UNITED STATES
DEPARTMENT OF THE INTERIOR
BUREAU OF LAND MANAGEMENT
SUNDRY NOTICES AND REPORTS ON WELLS

8. Well Name and No.
Carson Unit 19 No. 34

Re: Permanent Abandonment

CONDITIONS OF APPROVAL

Carson Unit 19 No. 34

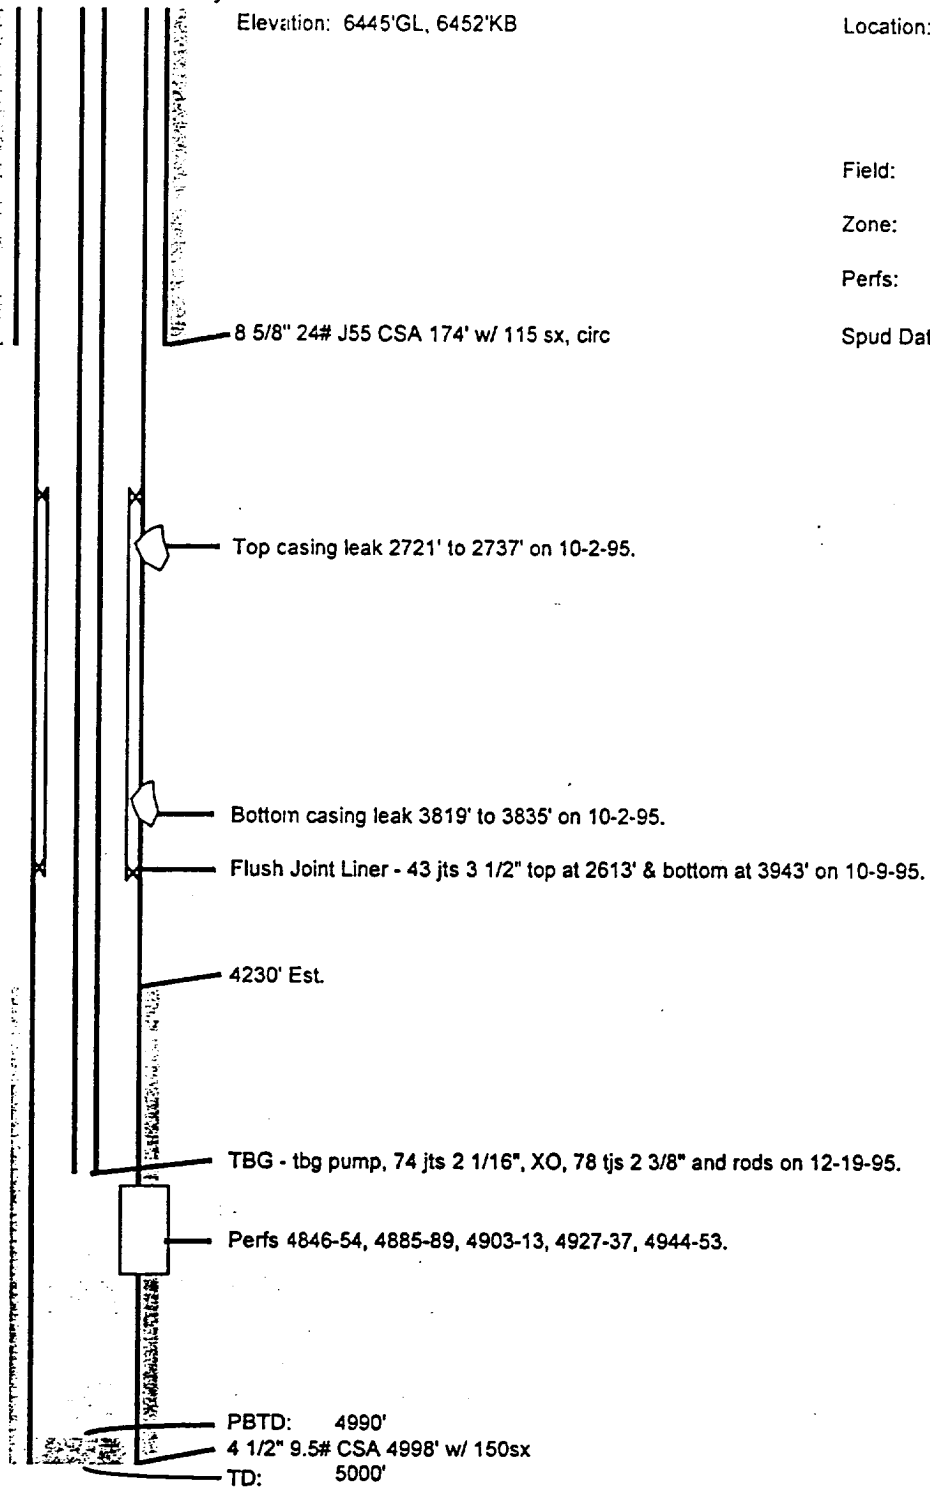
- a. Notify the Farmington BLM office at 505-599-8907 24 hours prior to commencement of plugging operations.
- b. Spot a cement plug through tubing from 4650' - 4753' to cover Gallup top @ 4753' ³⁶ 4686'
- c. Perforate and squeeze cement from 2000' - 2095' to cover the Mesaverde top @ 2095' ¹⁹⁵⁸ inside and outside the casing.
- d. Perforate and squeeze cement from 1160' - 1230' to cover the Pictured Cliffs top @ 1230' ¹¹⁷⁷ inside and outside the casing.
- e. Perforate and squeeze cement from 800' - 900' to cover the Frutiland top @ 900' ⁸⁶⁰ inside and outside the casing.
- f. Perforate and squeeze cement from 150' - 225' to cover the surface casing shoe inside and outside the production casing.
- g. Perforate and squeeze cement from surface to 50' inside and outside the production casing.
- h. Cut wellhead and install dry hole marker. Clear and remediate location.

3. The following modifications to your plugging program are to be made:

a) Place the Gallup plug from 4636' - 4753'.

b) Place the Mesaverde plug from 2008' - 1908' inside and outside the 4 ½" casing.

c) Place the Pictured Cliffs plug from 1279' - 1179' inside and outside the 4 ½" casing.

d) Place the Fruitland plug from 960' - 860' inside and outside the 4 ½" casing.

e) Combine the surface casing shoe plug and the surface plug from 351' to surface to cover the Ojo Alamo inside and outside the 4 ½" casing.

You are also required to place cement excesses per 4.4 of the attached General Requirements.
